EXTRACTS FOR DPI-WATER

2. RESPONSES TO ISSUES RAISED ABOUT THE AMENDED PROJECT

Figure 2.29.14
Year 15

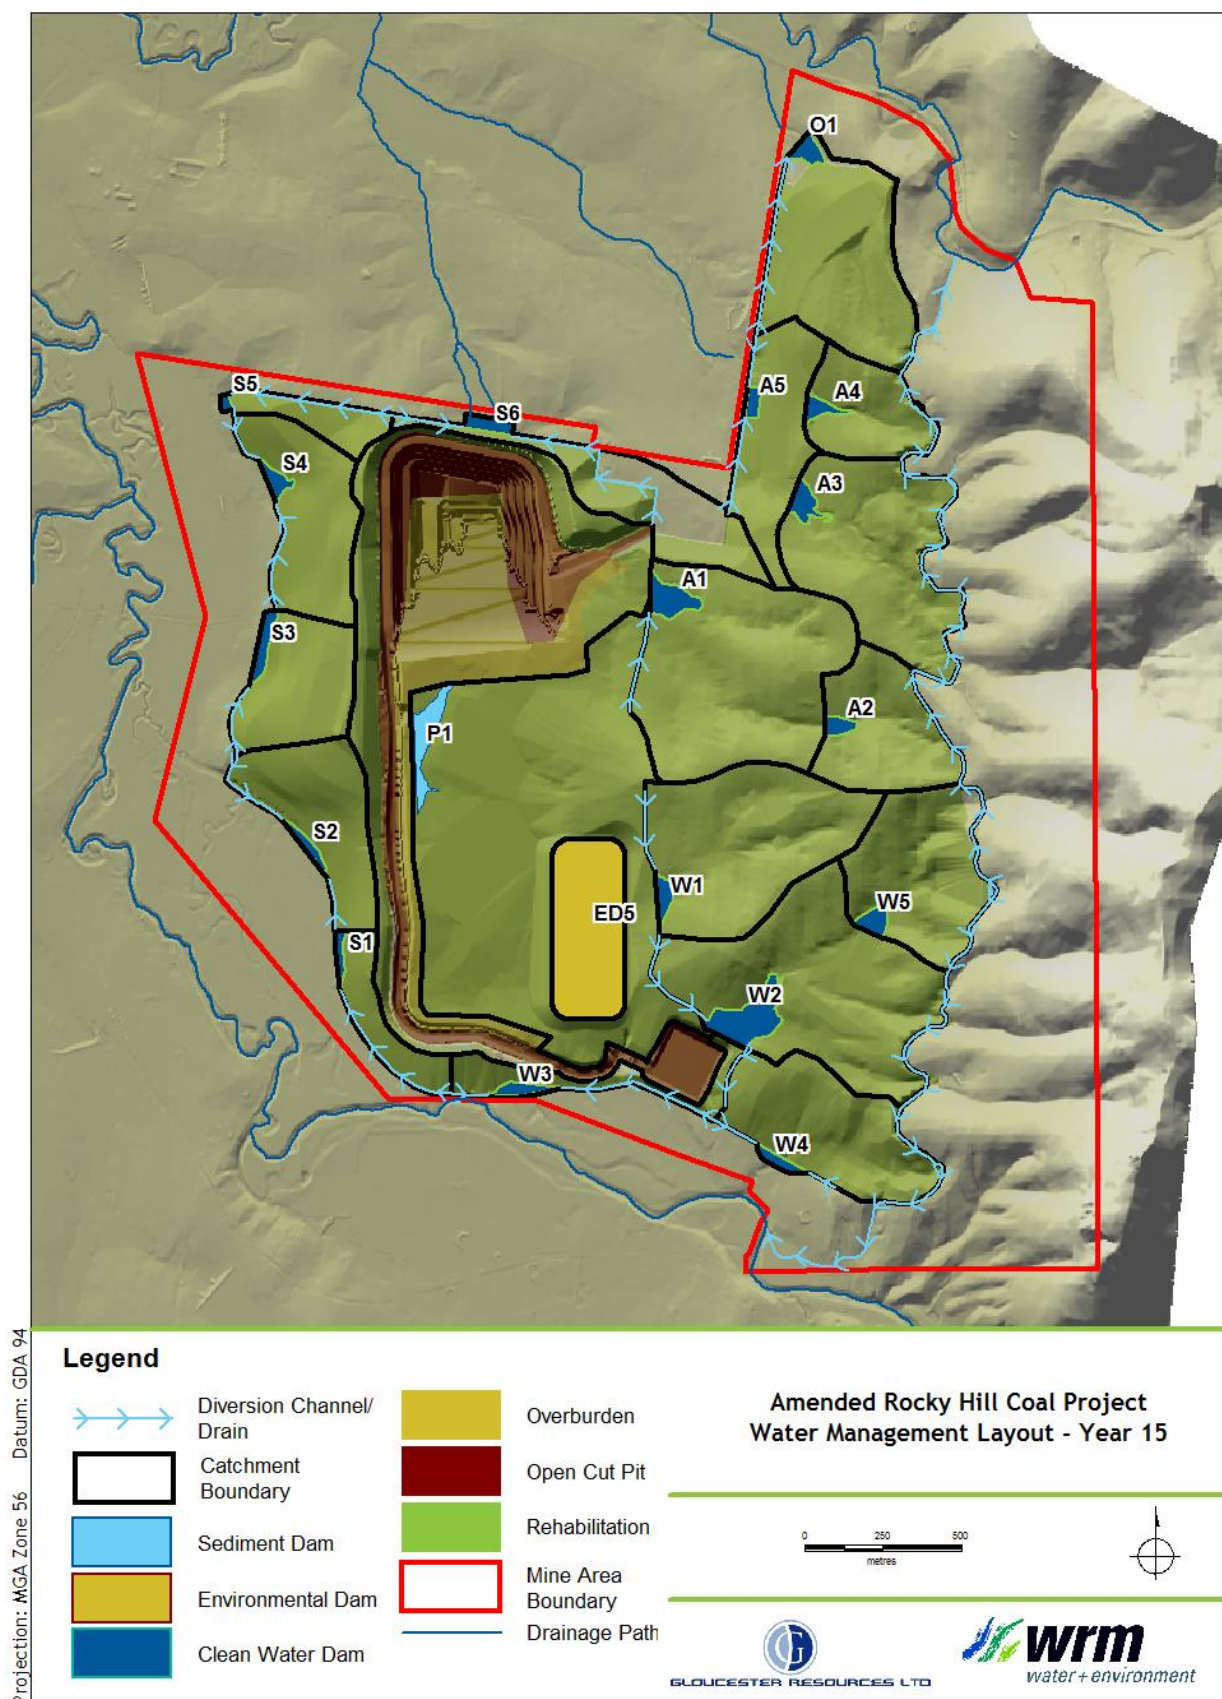
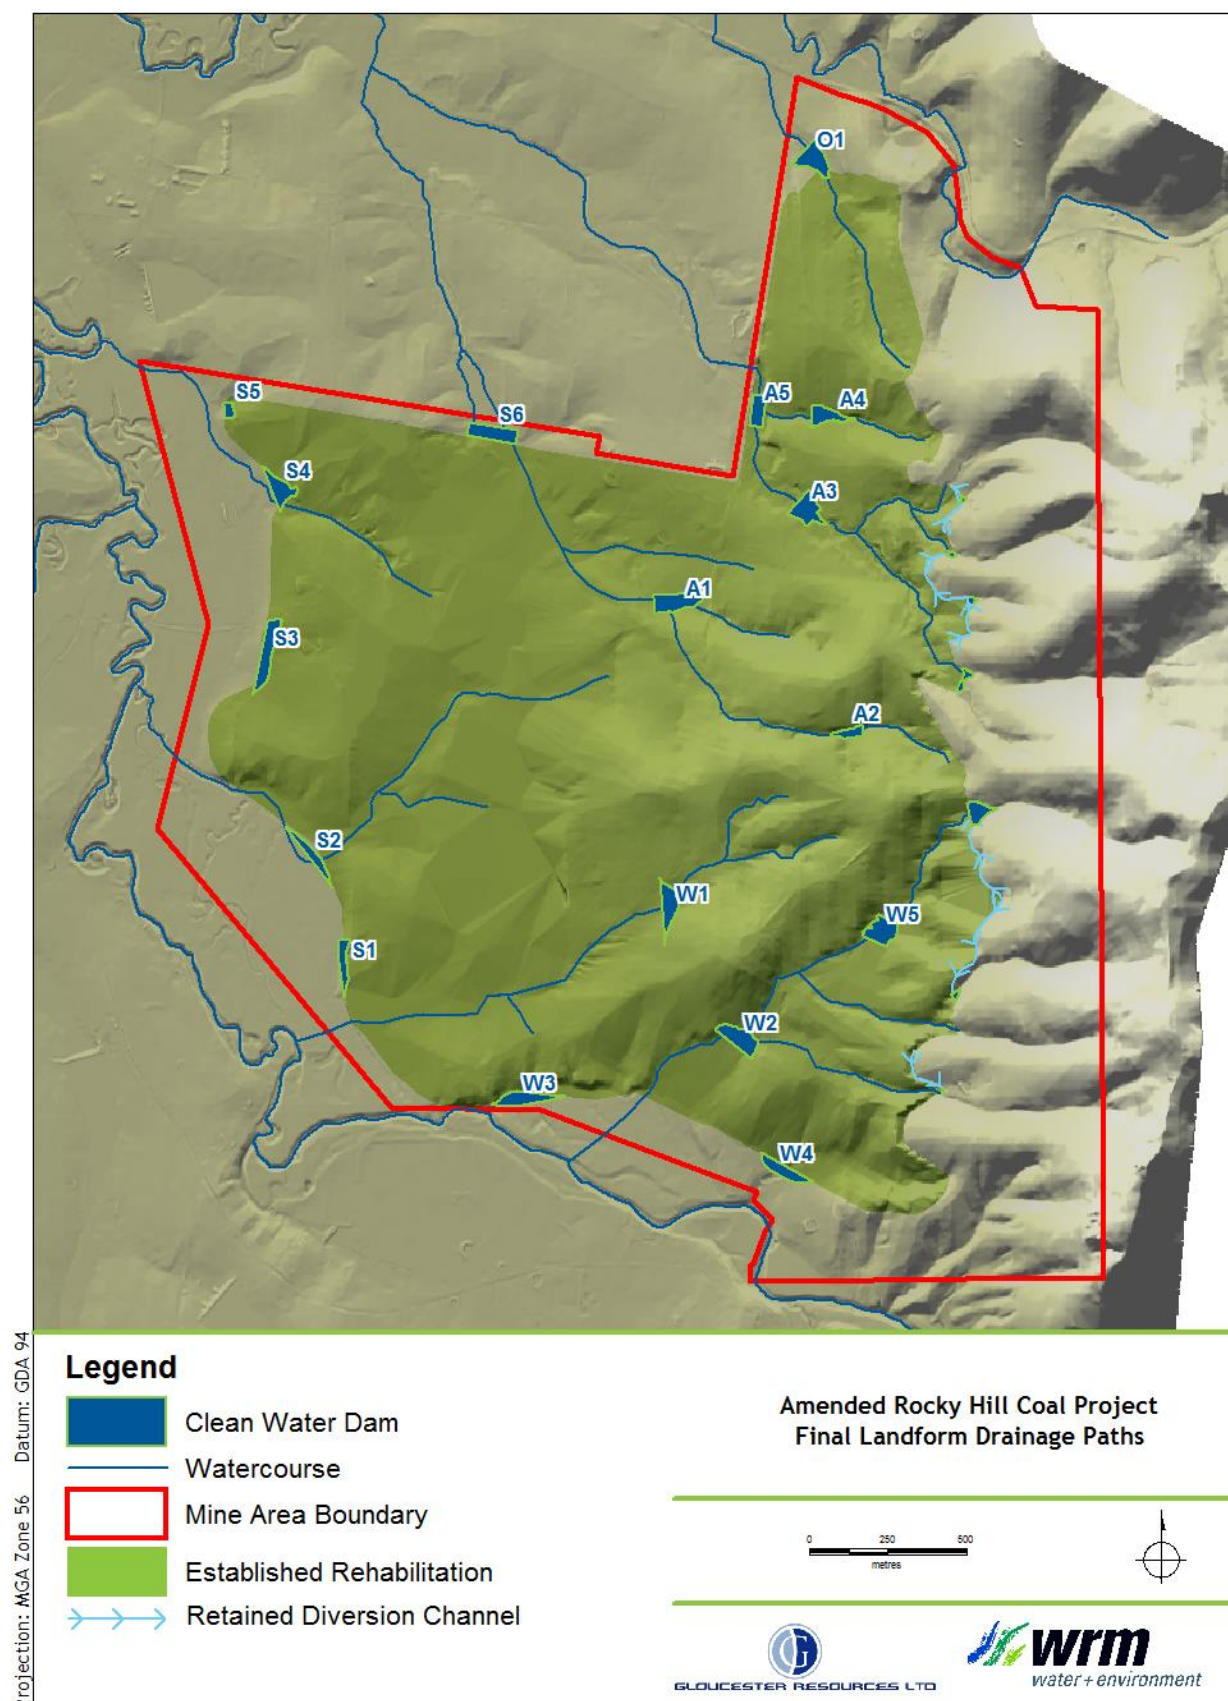
The volume of the proposed clean water dams appears to exceed the proponent's harvestable rights and surface water entitlement. Further information is required on how all proposed dams are to be accounted for, including proposed dams on 3rd order streams that do not fit within exemptions or harvestable rights provisions. This should include a table listing each dam, its strahler order, location, volume, purpose (e.g. clean water, sediment, saline), and the proposed accounting method (e.g. harvestable rights, WAL no., exempt) for different stages of the proposal.

The SWA (Section 1.5.2) gives a maximum harvestable rights dam capacity (MHRDC) for the amended Project of 194ML/yr. **Figure 2.29.10** to **Figure 2.29.15** reproduce Figures 3.2 to 3.7 from the SWA showing the location of all proposed dams. **Table 2.29.4** to **Table 2.29.9** give details of the various dams for each stage of the project including the Strahler classification of the watercourse on which they are proposed to be constructed as well as the proposed accounting method. Only those dams on watercourses with a Strahler classification of 1 and 2 can form part of the harvestable right requirement. It is, however, noted, that whilst three of the proposed dams are located on watercourses with a Strahler Classification of 3, during the life of the amended Project, upstream diversion of water would effectively reduce the Strahler classification of the watercourse on which the dam is located. It is noted that the farm dams constructed on the land to the north of the Mine Area (to receive/store treated water from the treatment plant) would effectively be turkey nest structures without any catchment and consequently would not be subject to any MHRDC requirement.

Water captured in clean water dams¹¹ and used on site would require an entitlement from the Avon River Water Source. The tables show the total volume required if all entitlements for clean water dams were to be offset against the Harvestable Rights held by GRL. From about Year 8, the total clean water dam capacity would exceed the MHRDC (352ML increasing to 436ML compared to the MHRDC of 194ML). GRL would rely upon its WAL entitlements (after offsetting baseflow losses) to account for the shortfall. Between Year 8 and Year 12, the remaining WAL entitlements would not be sufficient to make up for the shortfall (by up to 96ML), and GRL would compare the total clean water dam capacity to the MHRDC of 194ML and its WAL entitlements, and decide whether to decommission or reduce the capacity of the former sediment dams within the Mine Area or to acquire additional WAL entitlements during that period.
